**AMENDMENT NO. 1 to
INTERIM ADVICE NOTE 44/05
(IAN 44/05)
(Revision 3 of IAN 44)**

**INTERIM REQUIREMENTS FOR ROAD
RESTRAINT SYSTEMS
(VEHICLE & PEDESTRIAN)**

This Amended edition of IAN 44/05 supersedes IAN 44/05 issued 20th Jan 2005. Replace IAN 44/05 entirely with this amendment.

Summary of Amendment No. 1 changes:

Appendix 4.1. Road Restraint System Acceptance Procedure - Flowchart

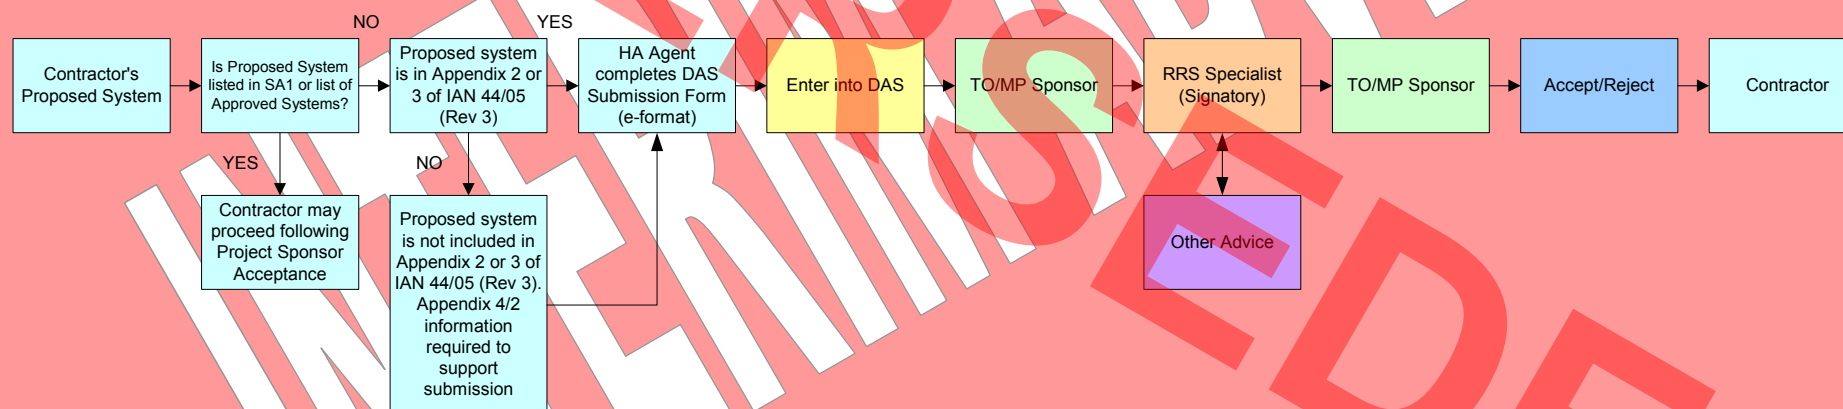
1. Page A2.2, 2.2 'Systems Acceptable for Use until January 1 2005' this should read '**Systems for Use until April 5 2005**'
2. Appendix 4.1, A4.1 - Acceptance of a Particular Road Restraint System (RRS) - (ROADS & STRUCTURES)
[IAN 44/05 Paragraphs 5.1.(i)(a), 5.1.(ii)(a), 5.1.(ii)(b) and 5.1.(ii)(d)]. There is no **5.1 (ii)(d)** and this should be deleted. It should read "**IAN 44/05 Paragraphs 5.1.(i)(a)(b) and 5.1.(ii)(a)(b)**"
3. Appendix 4.1, A4.1 Amendment to the Flow Chart text - 'Is Proposed System listed in SA1?' this should read '**Is Proposed System listed in SA1 or list of Approved Systems?**'
